### DRAFT REGULATORY GUIDE DG-1285

(Proposed Revision 3 to Regulatory Guide 1.174, dated May 2011)

## AN APPROACH FOR USING PROBABILISTIC RISK ASSESSMENT IN RISK-INFORMED DECISIONS ON PLANTSPECIFIC CHANGES TO THE LICENSING BASIS

**Figure 1 Relationship of Regulatory Guide 1.174 to other risk-informed guidance**

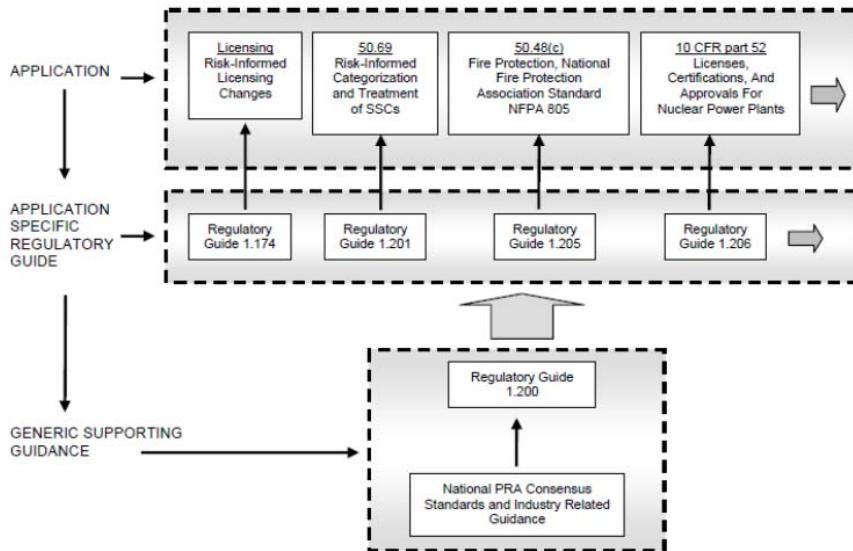
**Commented [GWP2]:** The implication is that there is margin in the QHOs. Perhaps this could be highlighted in some way?

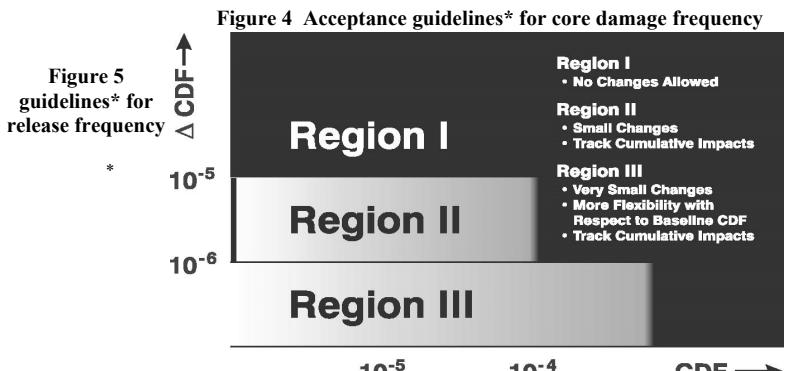
**Commented [GWP6]:** This should probably be updated as necessary to comply with the current situation re standards (e.g., low power and shutdown)

**Commented [GWP7]:** This is changing also (from three to two, but I doubt the new edition of the standard will be out in time to affect Rev 3 of RG 1.174, but it may deserve a footnote.)
